November 24, 2025
Subject: Dover Bridge #5118
Bridge Replacement Project
State WIN: 023120.00
Location: **Dover Foxcroft**
Amendment No. 5

Please make the following change to the Bid Documents:

WATER MAIN PROTECTION DETAIL

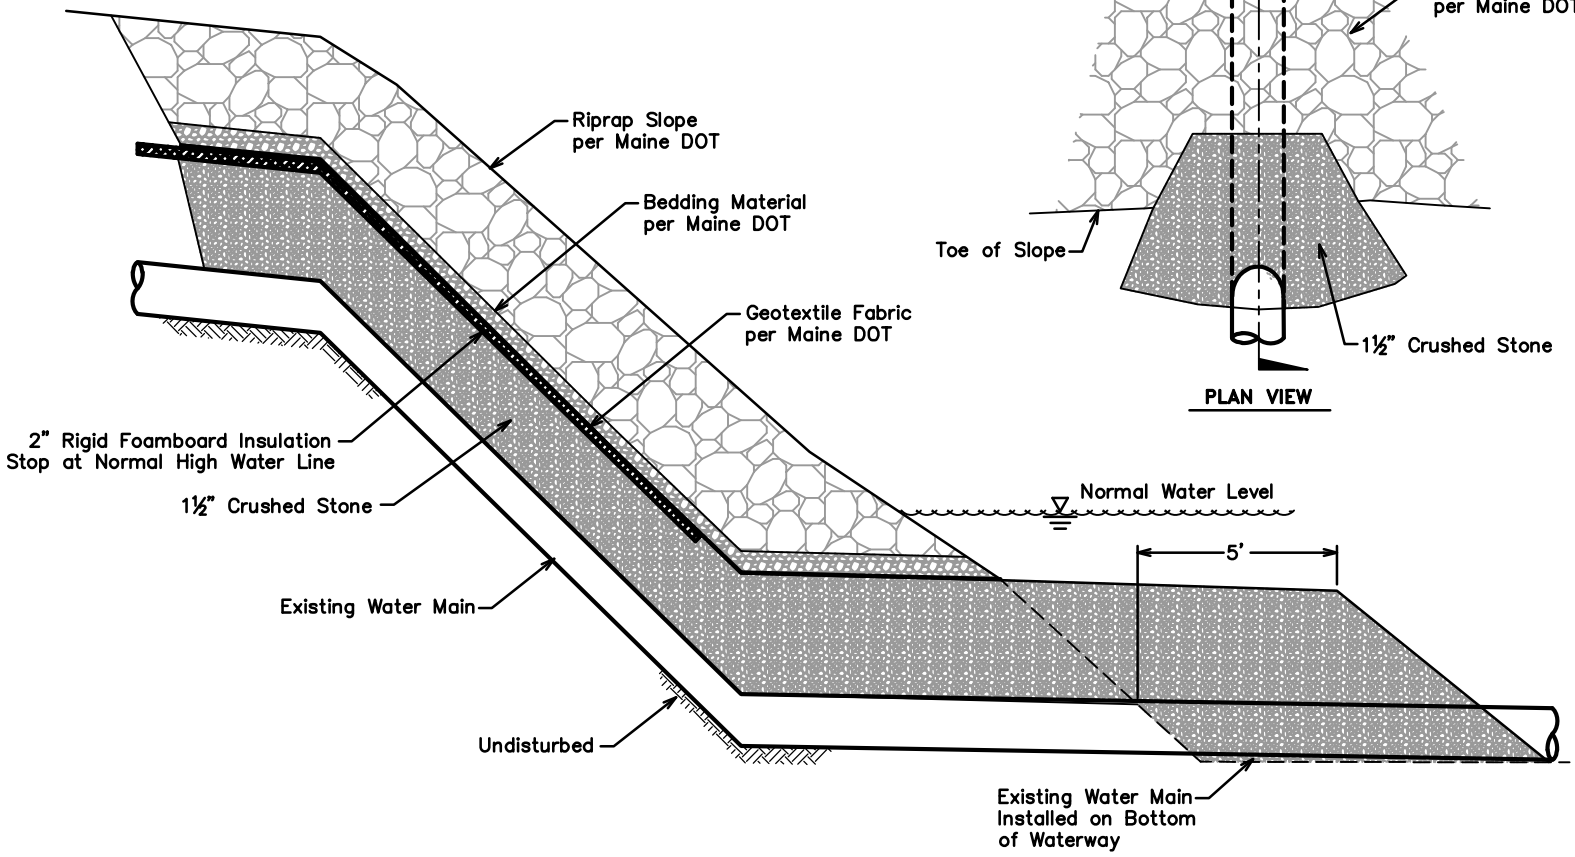
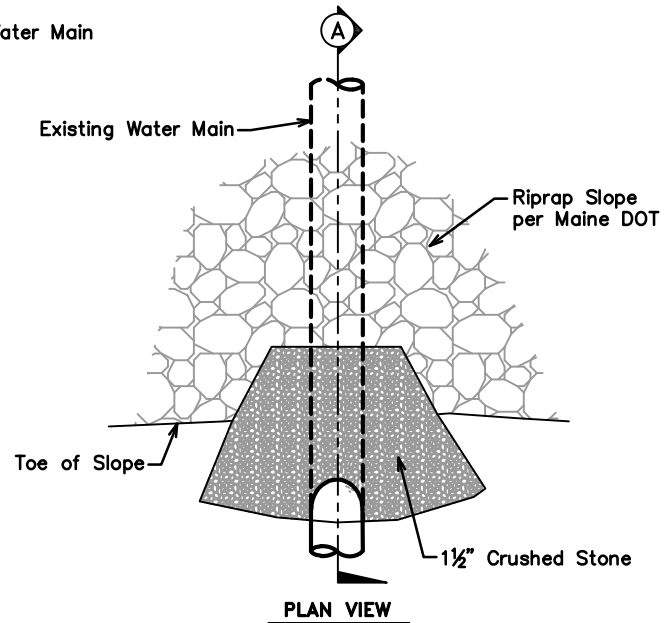
The existing water main located upstream from the existing bridge needs to be protected along the stream banks in accordance with the attached water main protection detail.

1. Detail is only for areas where 2' of cover between proposed bottom of riprap & existing main cannot be maintained.
2. The work to protect the existing water main shall not be paid for directly, but shall be considered incidental to related contract items.
3. The Contractor shall not excavate below the top of the existing water main.
